UNITED NUCLEAR
C O R P O R A T I O N

NLS-142

Subject: Amendment to SNM 777

SUBJECT: GENERAL

PROPOSED PORTABLE
VACUUM CLEANER
UNIT -
UNC - FRP RI
12-31-64

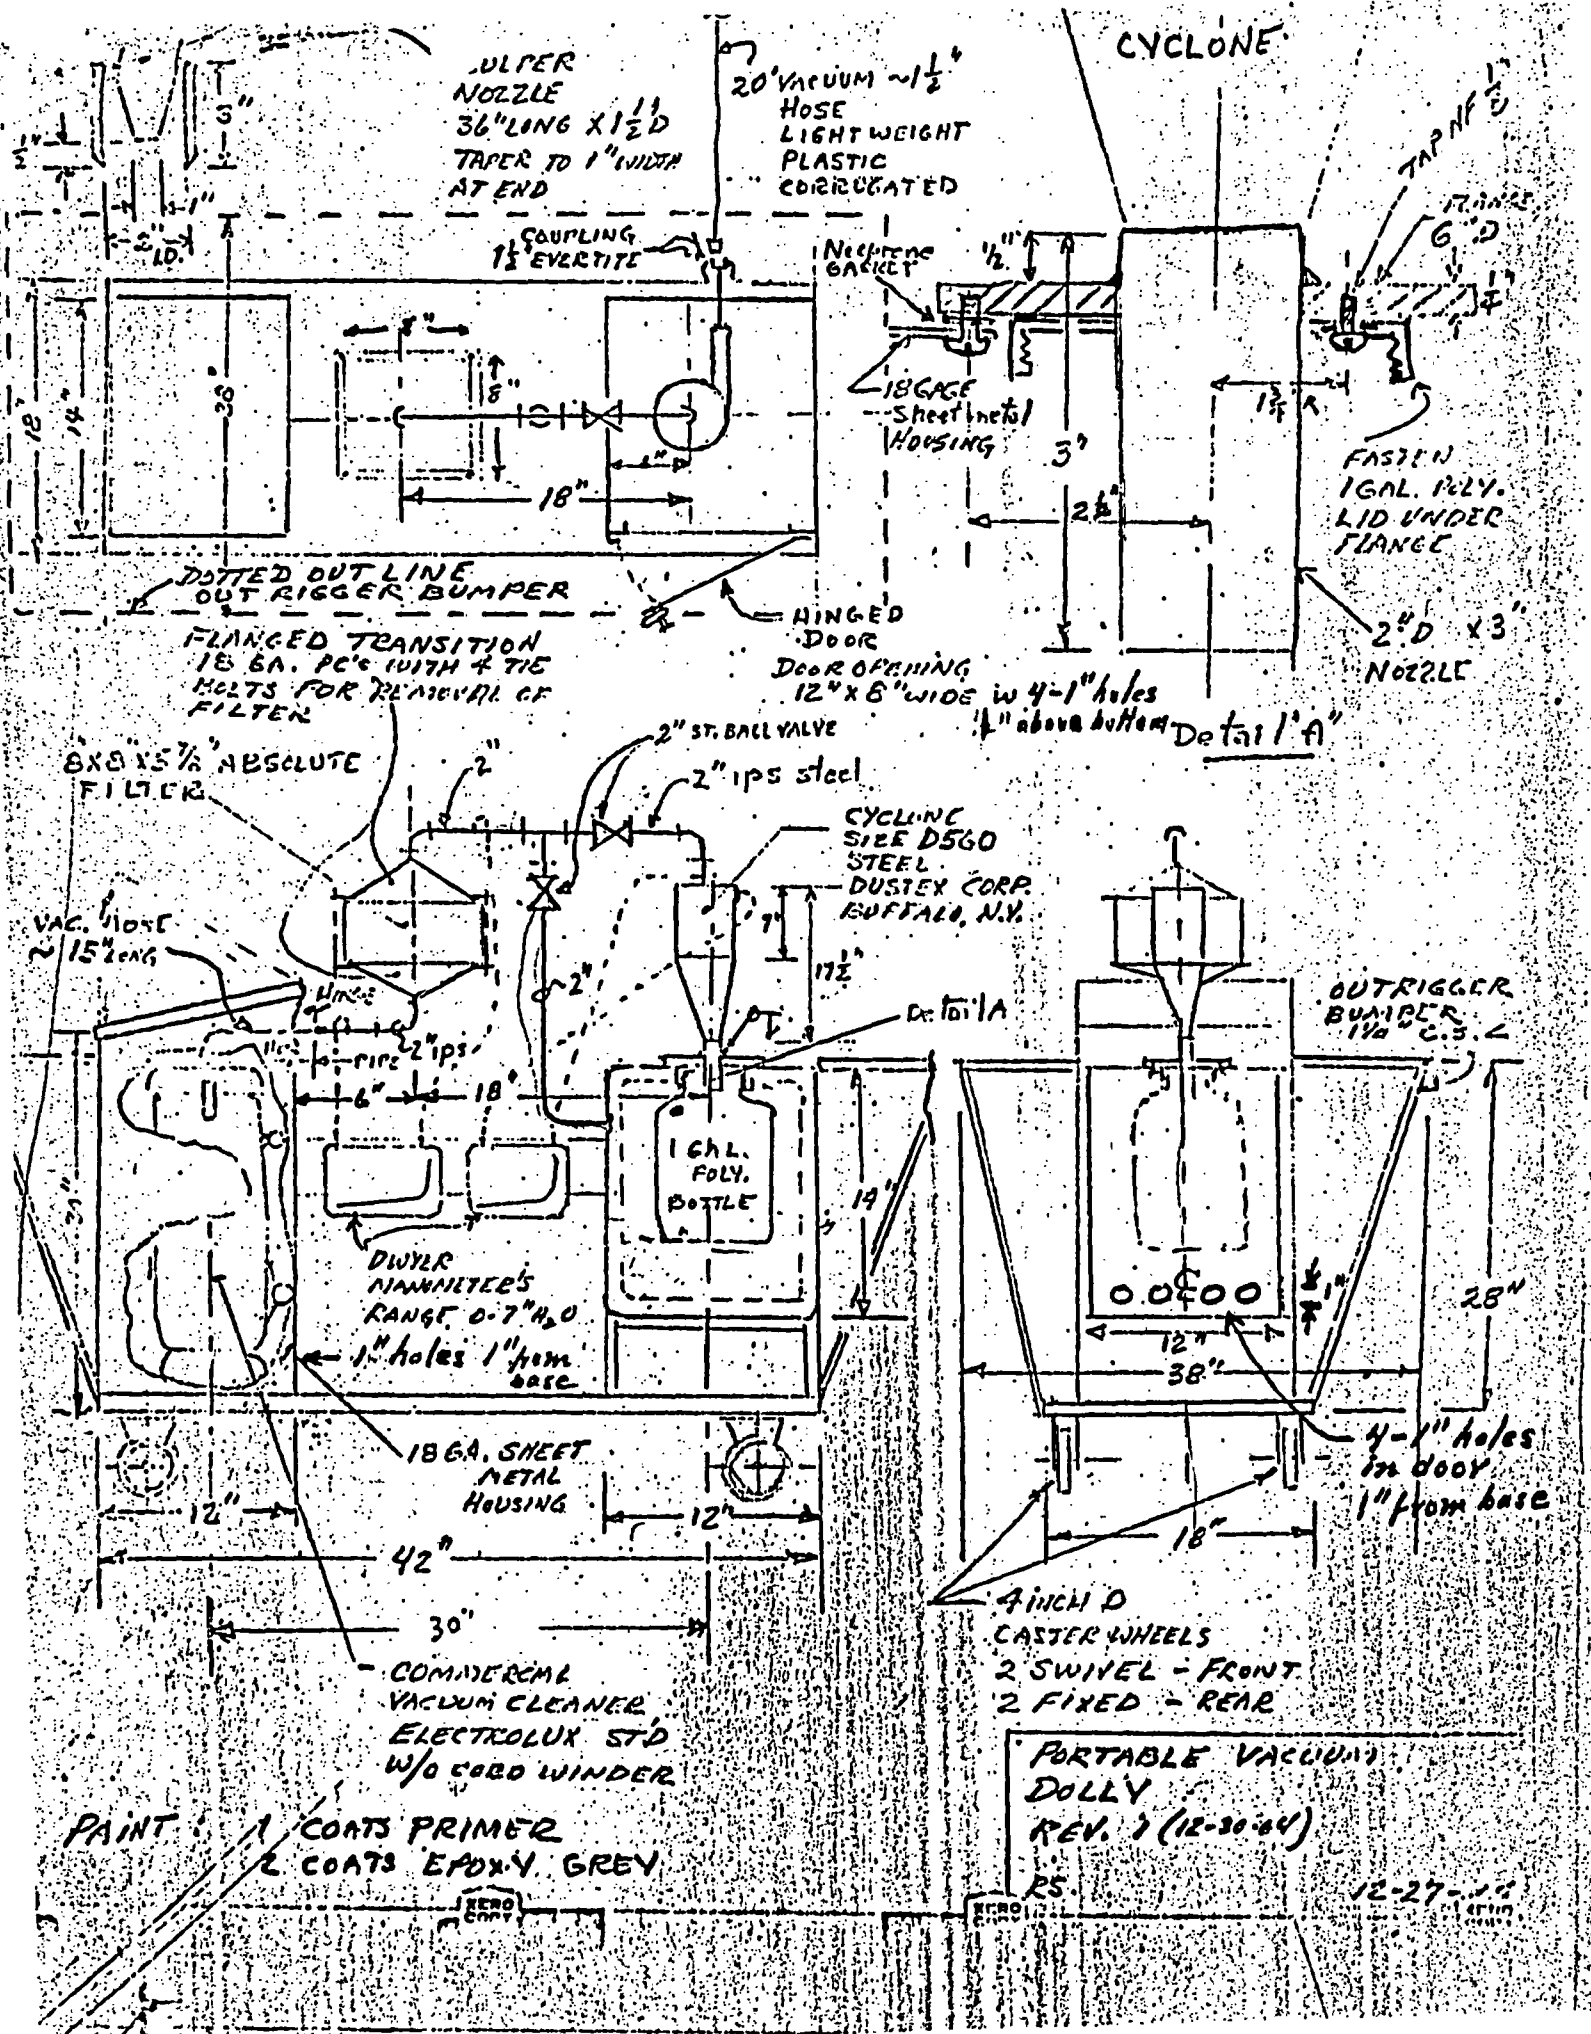
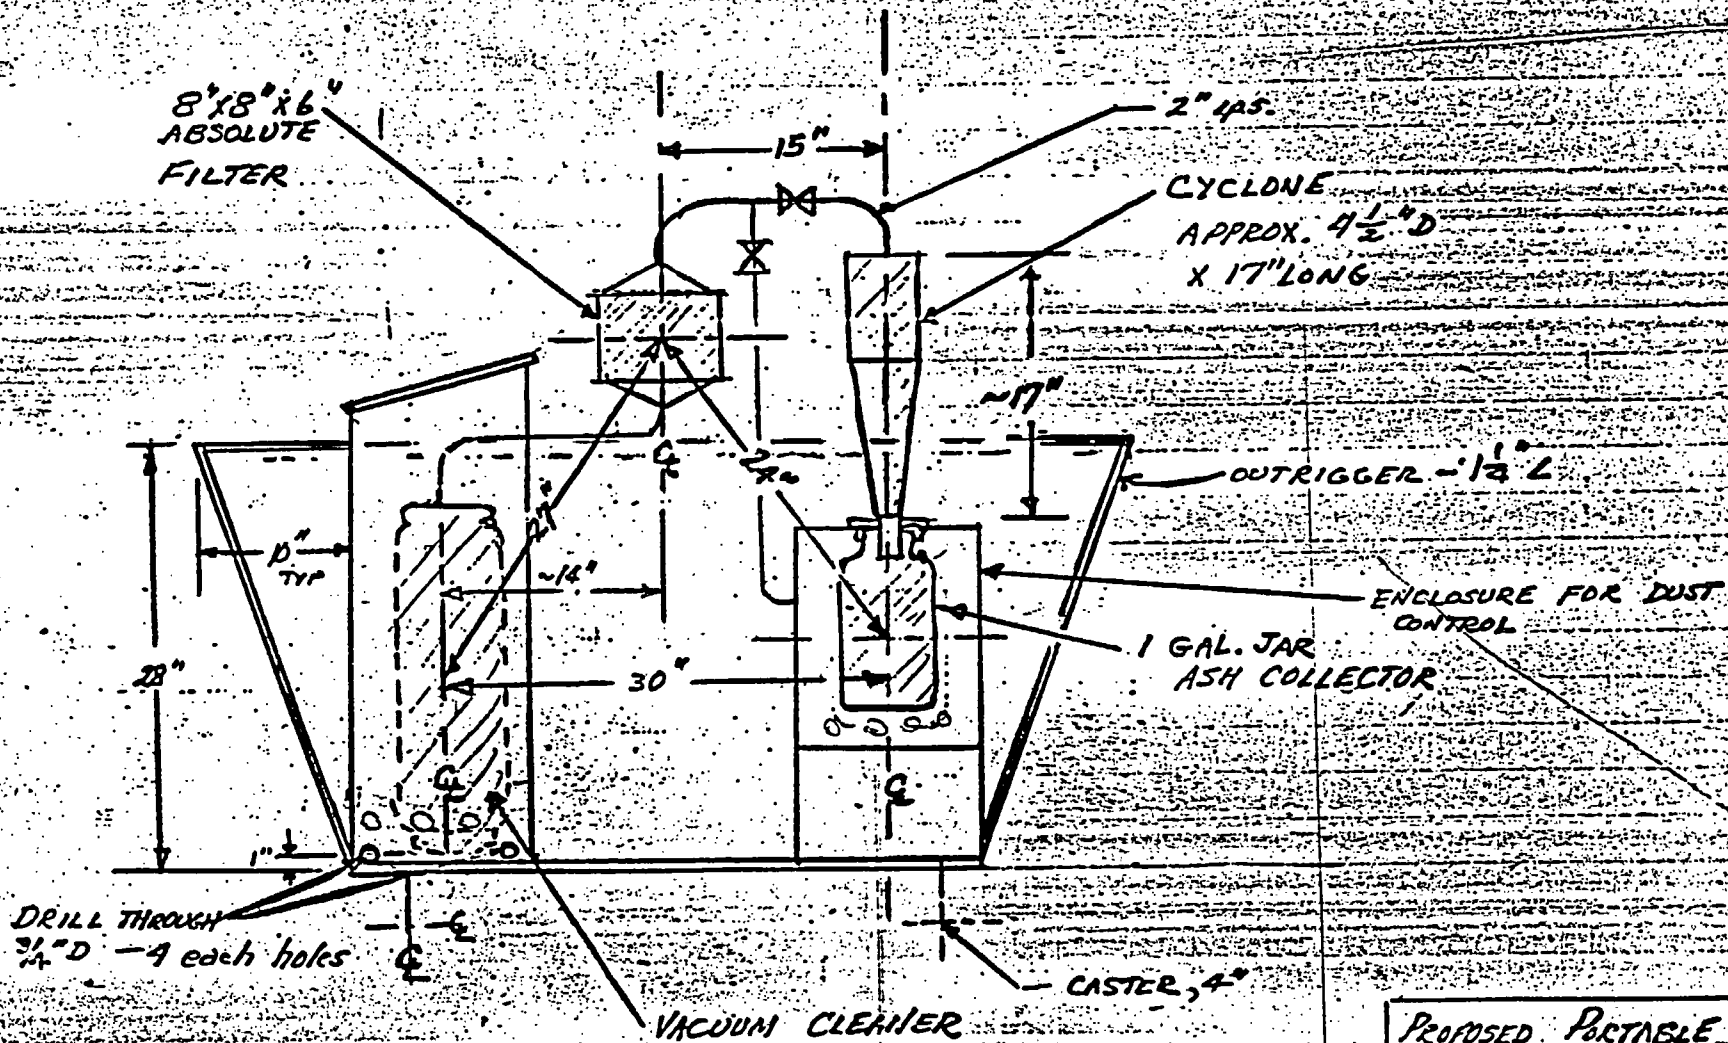
1201. Vacuum Cleaner

Dry materials such as residual ash in the DDU retort will be vacuumed from the source point to a safe volume container fastened under a 5" diameter cyclone mounted in a portable vacuum cleaner unit. Particulate fines which pass through the cyclone are collected on an 8" x 8" x 5" absolute - type air filter. A manometer is provided to monitor the pressure drop across the filter and the cyclone. The vacuum producer is a commercial tank-type vacuum cleaner approximately 7" wide at the widest point which is in the motor housing. The 3 ply filter bag which is used only in case of a rupture or leak in the absolute filter has a 2.7L volume. The vacuum cleaner and one gallon container are each separately housed on the portable frame. A steel outrigger bumper is fastened from the dolly at a 32" level above the floor and extends 10" from the outer perimeter of the dolly. The vacuum cleaner, mounted vertically, is spaced 30" on centers from the 1 gallon container and the cyclone. The 8" square filter is mounted between and 15" on centers from the cyclone.

Nuclear Safety Considerations: Each unit in the portable vacuum cleaner is dimensionally safe.

Interaction between units on the cart, considering the cyclone and receiver as the most reactive unit and for interaction calculations as a 6" diameter cylinder the total solid angle is:

due to filter	0.895
due to vacuum cleaner =	<u>0.1922</u>
	1.087 steradians

The outrigger framework on the cart assures a 19" minimum center to center spacing from adjacent equipment. The computed solid angle between the cyclone and receiver on the cart and an adjacent 5" diameter 42" long cylinder of uranium solution is 0.571 steradians.
